Model: SA11S1, SA15S1, SA8001

Subject: "Can't Play" is displayed on LCD.

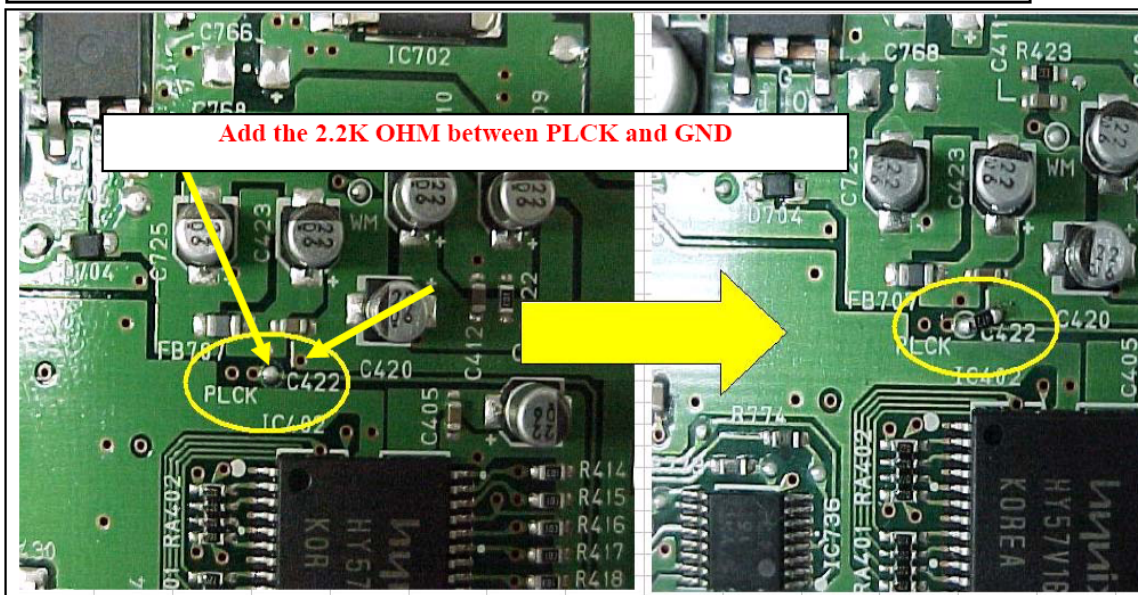
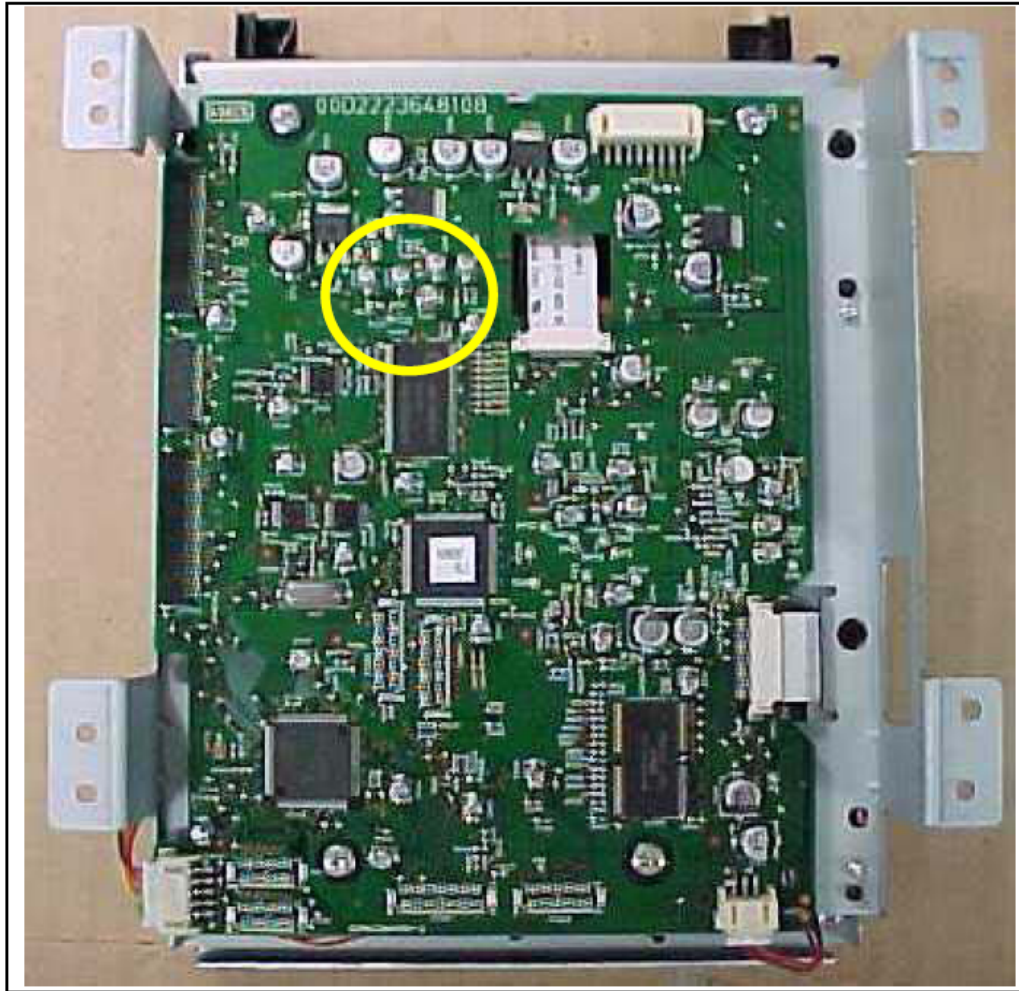
Symptom: During playback a Super Audio CD, "**Can't Play**" is displayed on LCD.

Solution: Mount 2.2K OHM on the Super Audio CD PWB Module where indicated.

Mount POS.NO. R410 2.2K OHM (PART NO. 00D2472008926) onto the Super Audio CD PWB Module.
